APPEAL SUMMARY

Appeal ID: 14720	Project Address: 6204 NE 8th Ave (South Lot 3)
Hearing Date: 3/8/17	Appellant Name: Roseann Johnson
Case No.: P-003	Appellant Phone: 9712216734
Appeal Type: Plumbing	Plans Examiner/Inspector: LUR Planner: Sean Williams; BES LUR: Ben Kersens; FP: Unknown
Project Type: residential	Stories: 2 Occupancy: Residential Housing Construction Type: Residential
Building/Business Name:	Fire Sprinklers: Yes - Lot 2 & 3 Homes to be determined at final plat
Appeal Involves: other: Shared Drywell for Stormwater Management	LUR or Permit Application No.: 16-182762 LDS
Plan Submitted Option: pdf [File 1] [File 2] [File 3] [File 4]	Proposed use: Shared drywells for Lots 2&3 with attached homes

Appeal item 1

PROPOSED CONDITIONS

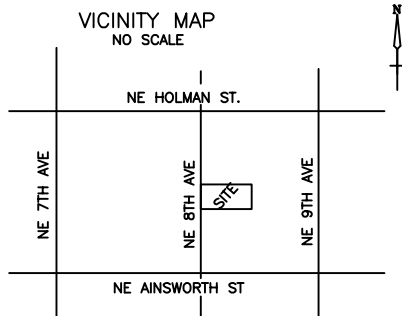
Code Section	308.1
Requires	<p>Section 308.1</p> <p>Except as otherwise provided in this code, no plumbing system, drainage system, building sewer, private sewage disposal system, or parts thereof shall be located in any lot other than the lot that is the site of the building, structure, or premises served by such facilities. The stormwater management facility for each lot shall be entirely independent.</p>
Proposed Design	<p>The subject site is currently under consideration for a three-lot land division with a private tract 'A' private street. One shared dry well is proposed to serve Lots 2 and 3. (An individual dry well is proposed to serve Lot 1, and an individual dry well is proposed to serve the private tract 'A' street; private street SD permit 123240). The shared dry well for lots 2 and 3 is proposed to be located within a reciprocal 10 foot X 10 foot easement. The dry well itself will be located a minimum of 10 feet from the building structure and 5 feet from any property line as measured to the center of the facility. Connections between each unit of each structure and the associated dry well will not cross property lines.</p>

Reason for alternative	<p>Lots 2 and 3 will be developed with an attached homes structure consisting of two units sharing a common wall. These units will function as individual dwelling units. Given the relatively narrow widths of the proposed lots 2 and 3, shared dry wells will allow for increased Title 11 tree density, feasible front yard tree planting required by community design standards (33.218.100), as well as private street trees to be planted within 5' of the street tract, required by the administrative rule for private rights-of-way. Due to the smaller size of the proposed lots, the common wall</p>

construction of the two-unit attached structure, and the tree requirements, a shared dry well in the front of lots 2 and 3 seems most practical. The dry well will only pick up roof runoff and will meet sizing requirements based on roof area of the two-unit attached structure. At a 6/12 roof pitch, the total roof area of the attached structure is proposed to be approximately 2,110 square feet, certainly within the capacity for a 4 foot X 5 foot dry well.

Shared Drywell: Granted provided an Operations and Maintenance agreement and easement are recorded.

Maintenance agreement and easement must be reviewed and approved by Bureau of Development Services prior to recording. Appellant shall contact Sean Williams (503-823-7612) for information.
